The Commission has issued the enclosed Amendment No. 4, Technical Specification Change No. 14 for License No. DPR-38; Amendment No. 4, Technical Specification Change No. 9 for License No. DPR-47; and Amendment No. 1, Technical Specification Change No. 1 for License No. DPR-55, for the Oconee Nuclear Station, Units 1, 2, and 3. These amendments are in response to your request dated August 19, 1974.

OCONEE NUCLEAR STATION, UNIT 1

ATTACHMENT TO LICENSE AMENDMENTS

OCONEE NUCLEAR STATION, UNITS 1, 2, AND 3

FIGURE 6.1-1 | 14/9/1

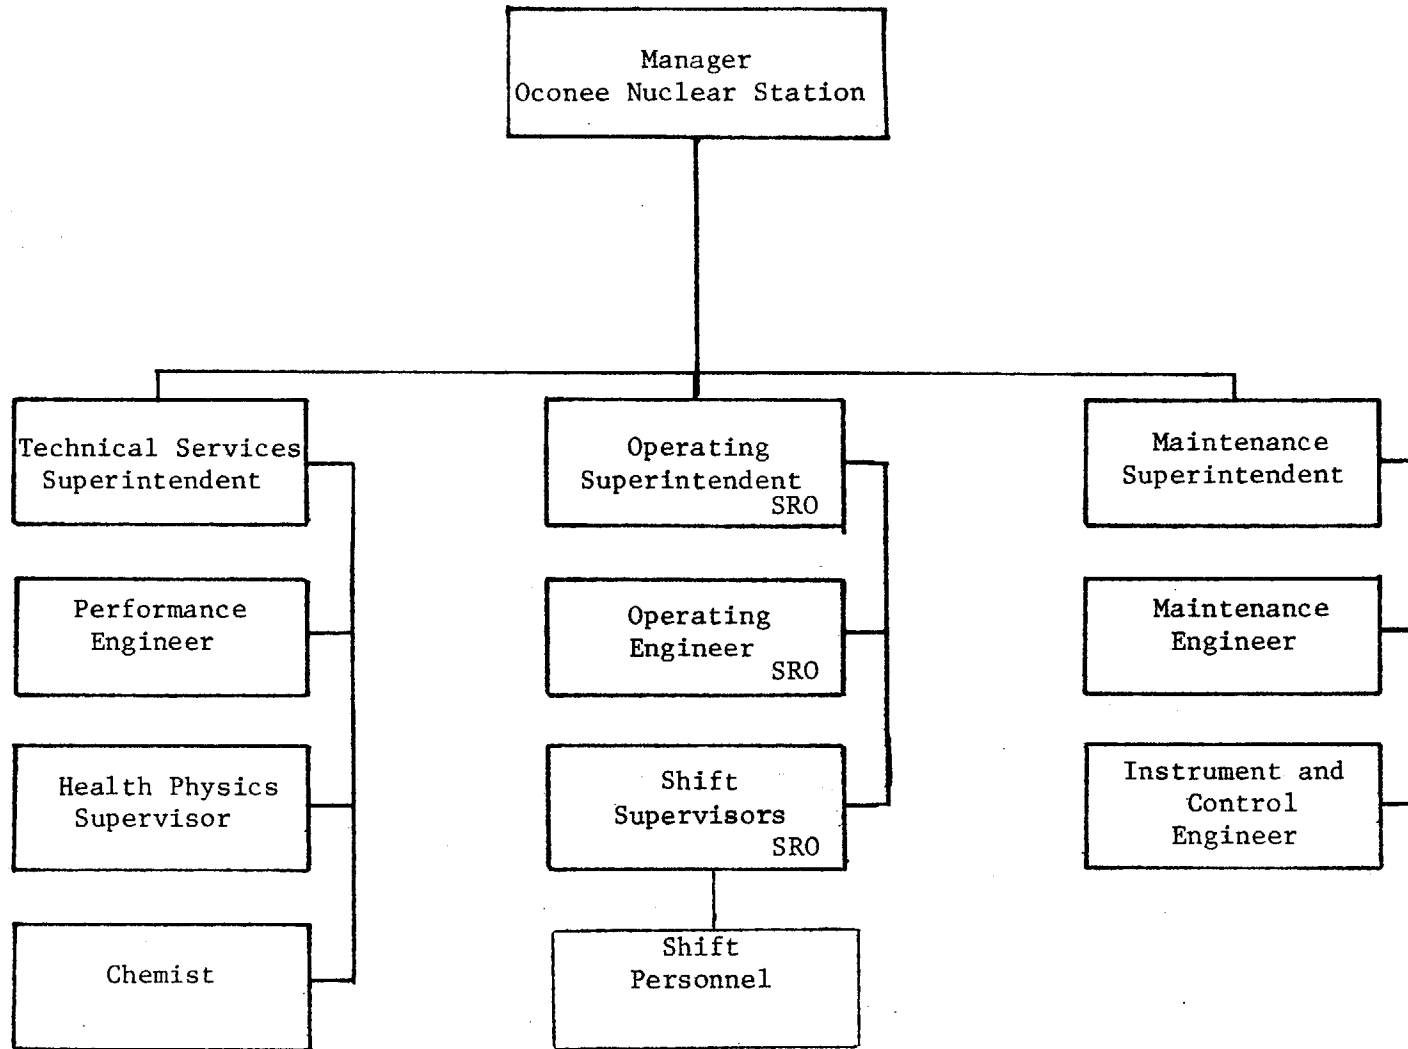
The following changes to the station organization chart have been proposed:

1. The title of Plant Superintendent will be changed to Station Manager.
2. The position of Assistant Plant Superintendent will be eliminated.
3. Clerical Staff and Visitor Center Staff will be removed from the chart.
4. The supervisor's titles in the two service groups and the operating group will be changed from Engineer to Superintendent.

OCONEE NUCLEAR STATION
MANAGEMENT ORGANIZATION CHART
FIGURE 6.1-2 | 14/9/1

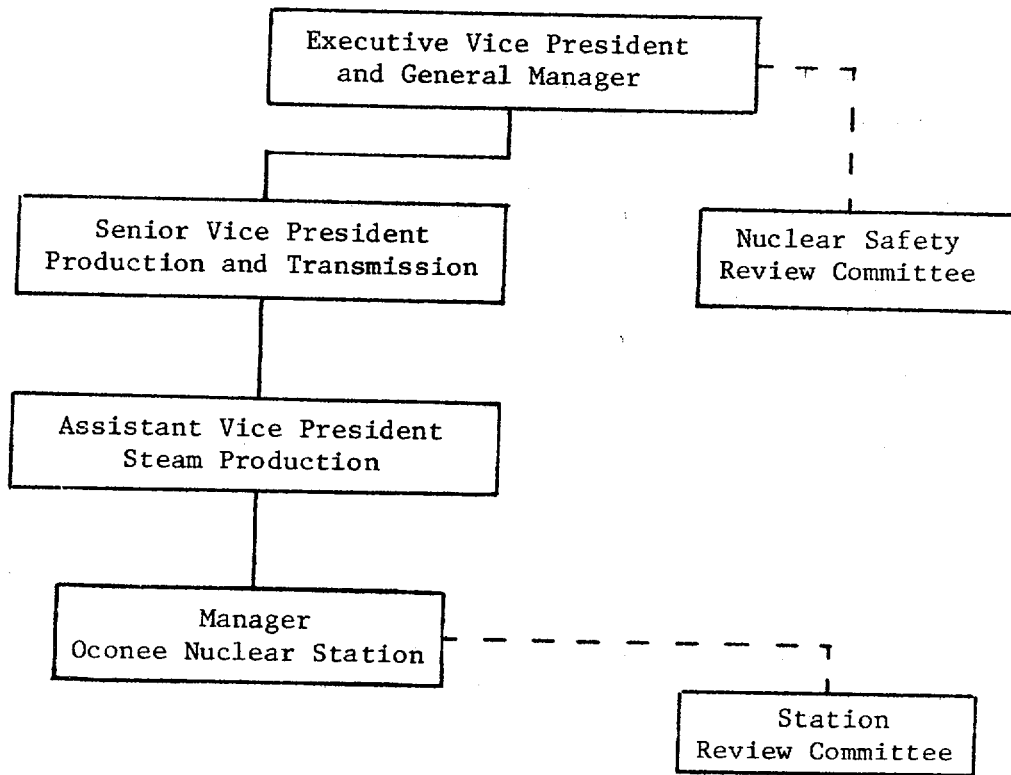
The proposed change in the management organization chart (Figure 6.1-2) will simplify the reporting channels for the Safety Review Committee and the Station Review Committee.
